SUBJECT: TASK ACTION PLAN FOR USI A-47, "SAFETY IMPLICATIONS OF
CONTROL SYSTEMS"

IE Bulletin No. 79-27

LOSS OF NON-CLASS-1-E INSTRUMENTATION AND CONTROL POWER SYSTEM BUS DURING OPERATION

Docket No. 50-312
Rancho Seco Nuclear Generating
Station, Unit No. 1
IE Bulletin 79-27

FIGURE 1

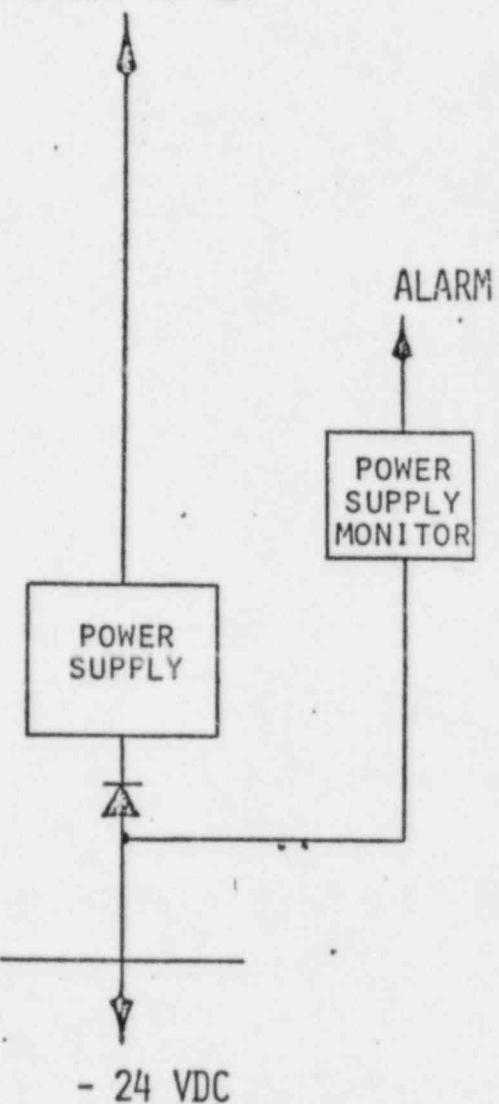
Following these events above, parallel inverter supply was added to the ICS and NNI DC supplies. In addition, an automatic bus transfer was added to the 118 VAC instrumentation supply. See Figure 1 for initial power supply configuration and Figure 2 for modification performed.

FIGURE 3

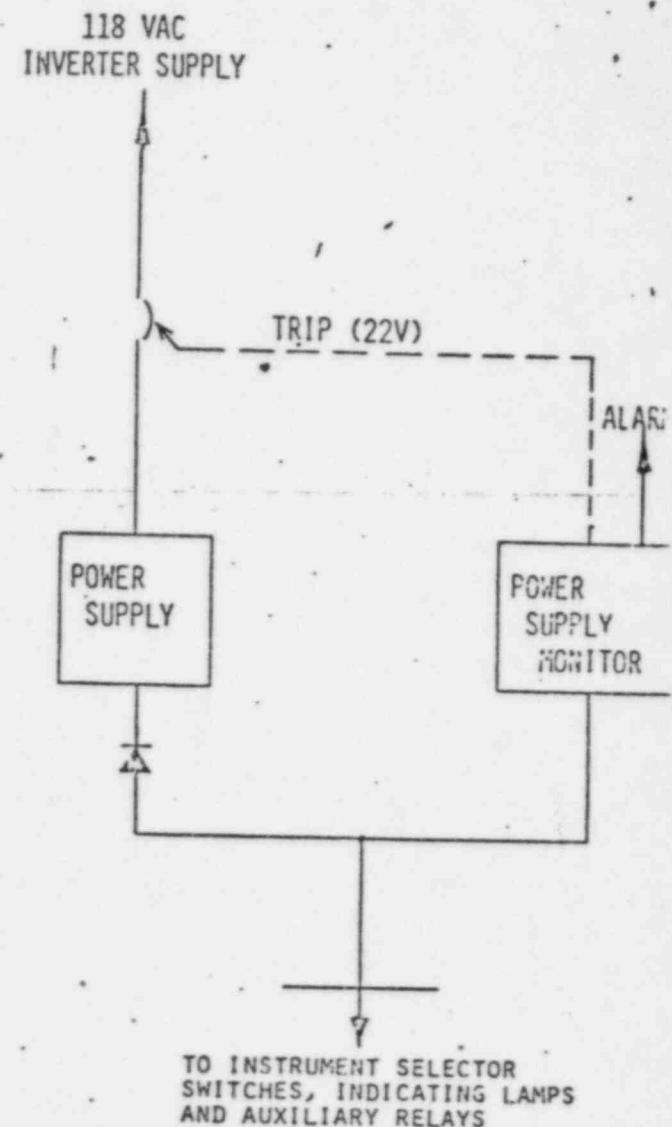
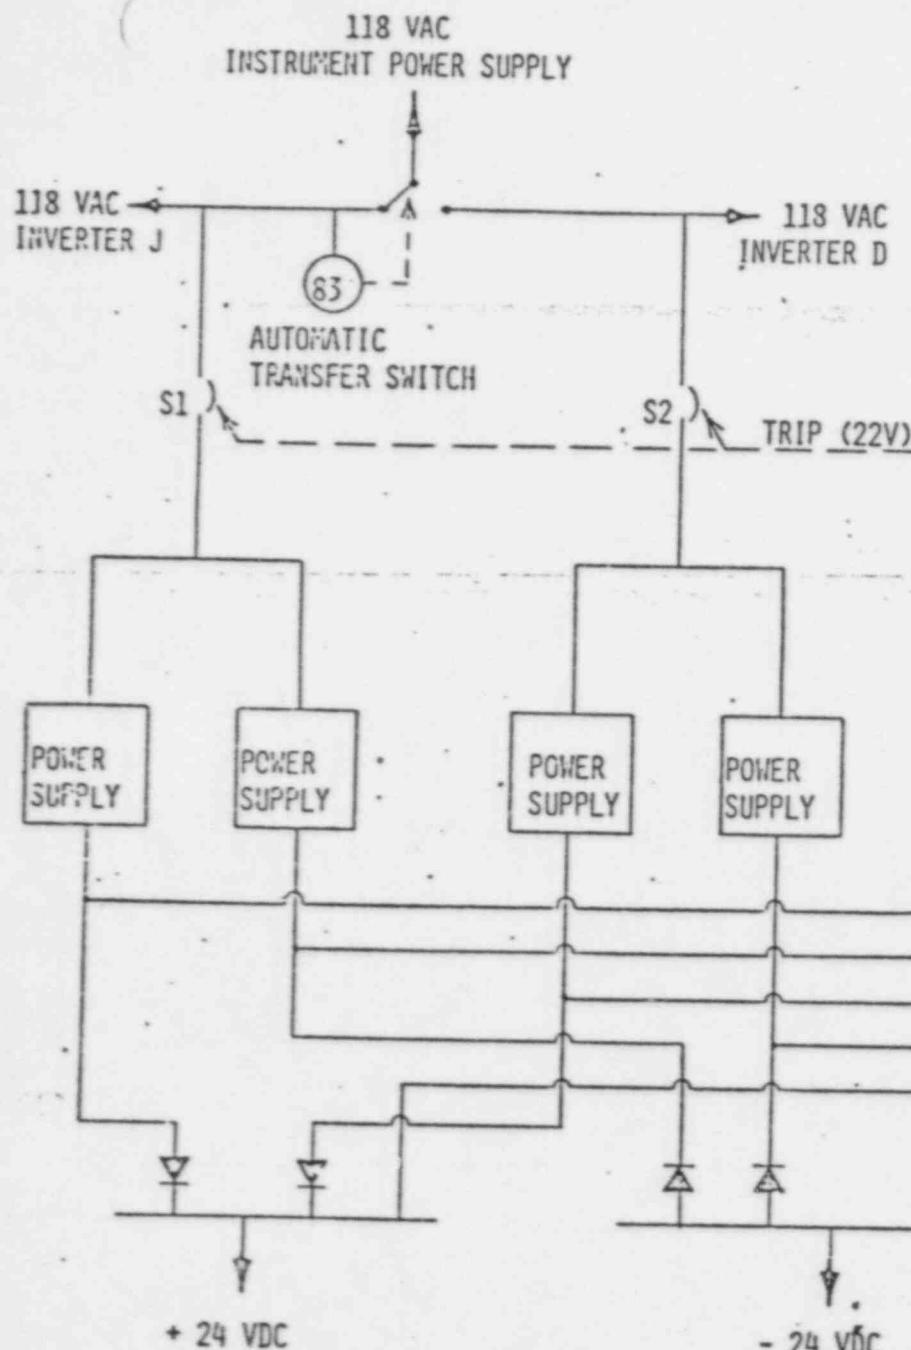
e. RECOMMENDATION: Provide a separate power supply module for the NNI instrument selector switches, associated indicating lamps and auxiliary relays. This circuit would be similar to that shown in Figure No. 3 attached. This change would not be likely to prevent a plant trip, but it would reduce the quantity of instrumentation lost for a short circuit condition identical to that of March 20, 1978.
